寄件者: Wilfred Ka Hing CHU/PLAND  
寄件日期: 2025年06月10日星期二 10:57  
收件者: tpbpd/PLAND  
副本: Tracy Wing Sum LAW/PLAND  
主旨: Fw: Comments on Planning Application No. A/YL-PN/84  
附件: 清拆圖.pdf; 填土區域圖.pdf; P.5-01.jpg; P.6-01.jpg; P.8-01.jpg; P.10-01.jpg; 布局設計圖.pdf

FI for A/YL-PN/84

Regarding your submission of planning application no. A/YL-PN/84, please find below comments from concerned Government Departments for your further action please.

清拆圖

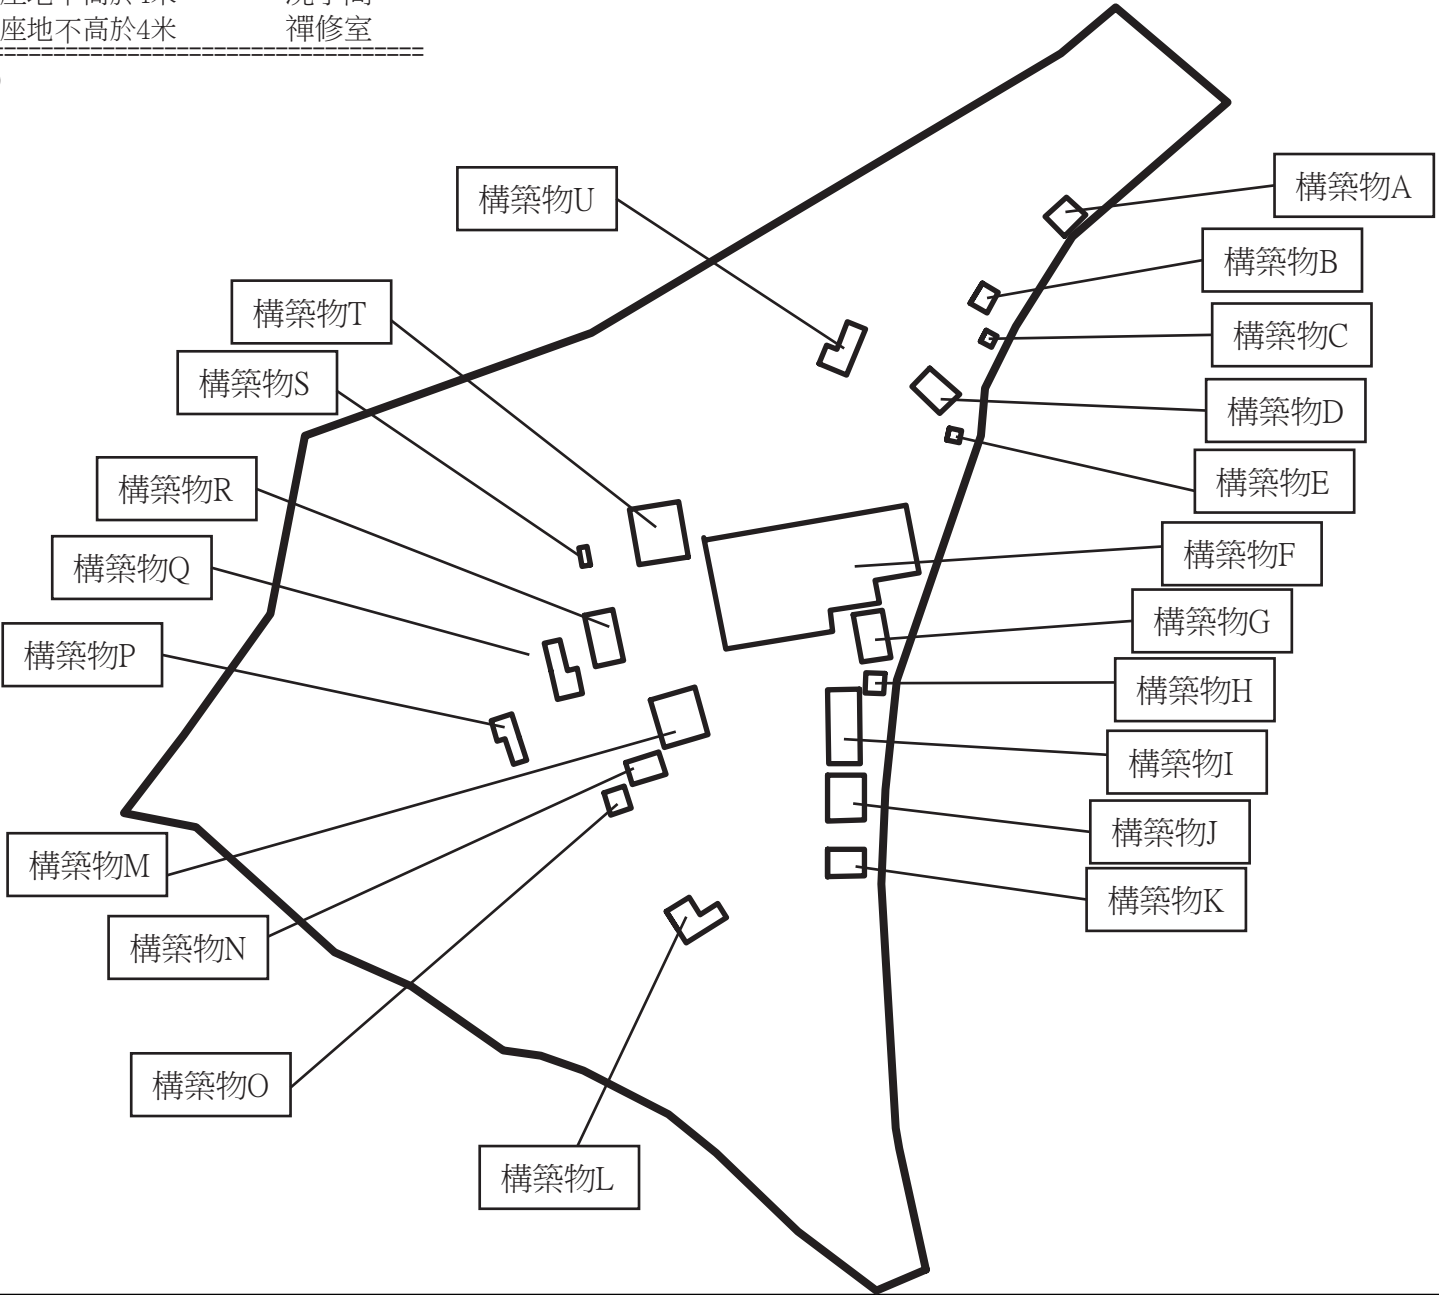
- all the information related to the construction of the existing structures on the subject site;
- details of the construction of the existing structures, including excavation, leveling and filling up of the subject site. Are there any antiquities or supposed antiquities found during the construction of the structures?
- Photos on the subject site prior to and during the construction of the structures showing the condition of the site before, during and after the construction;
- to clarify with AMO whether there is any drainage works proposed for the development\*. If affirmative, the applicant is required to provide details of the drainage works, e.g. the location, extent and depth of the proposed ground excavation for AMO's further comment.

2. 附上清拆圖。

回覆 古蹟辦: 1. 布局設計圖及清拆圖有相關資料。
